ADDENDUM No. 1

Reference: Springville Readiness Center Upgrade
Utah National Guard
DFCM Project No. 08032470

ADDENDUM #1
RENOVATION OF READINESS CENTER
125 SOUTH 700 EAST
SPRINGVILLE, UTAH

SHEET AE101

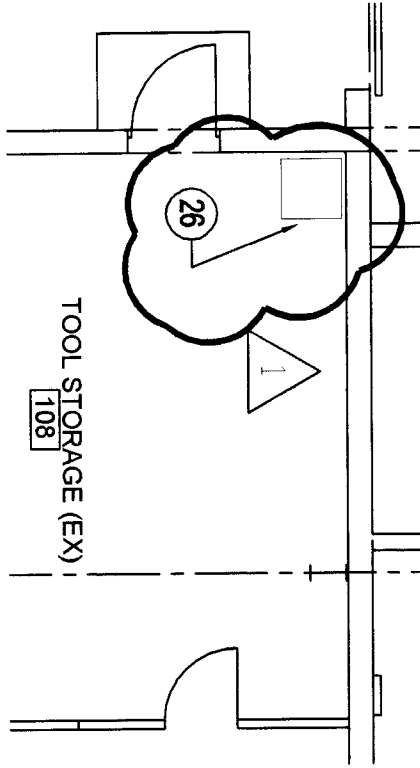
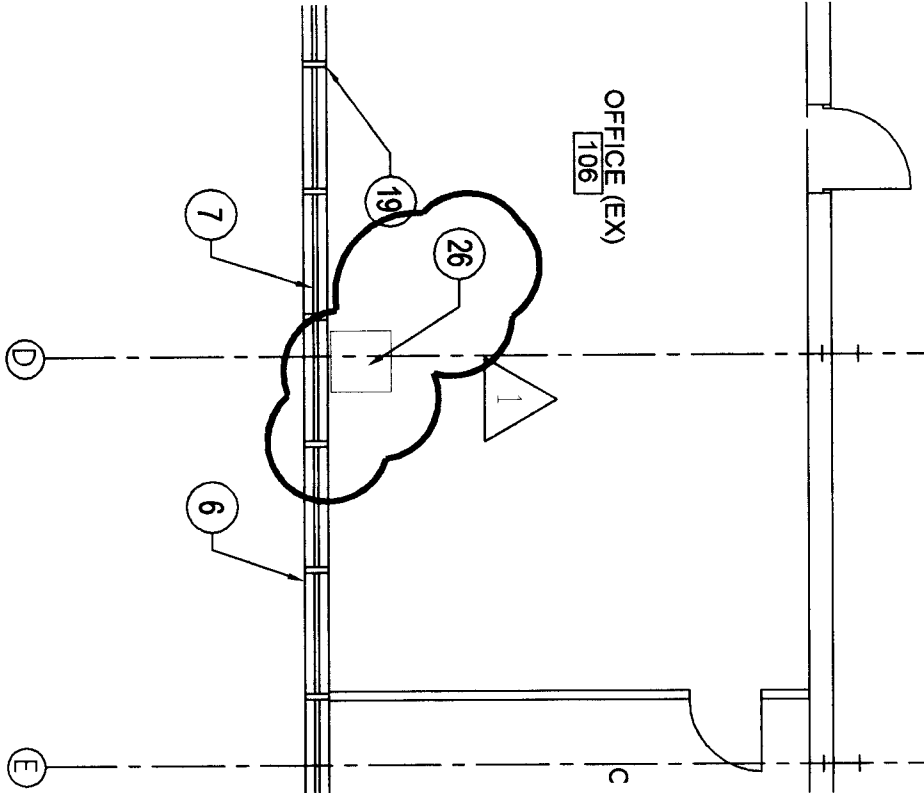
1. Revise Keyed Note 26 to read as follows. See also attached as-built drawing for location of existing pipe tunnel (for reference only). Relocate keyed note 26 to the northeast corner of tool storage 109 and in office 106 as shown on attached partial AE101.
26. ACCESS DOOR TO EXISTING PIPE TUNNEL BELOW FLOOR FOR TYING INTO SEWER & WATER LINES
2. Delete "UPPER ENCLOSED PLAN" This work will be done by the Guard. Contractor to still complete demolition called out by note 3 on AD101.
3. Delete Keyed Note 14.
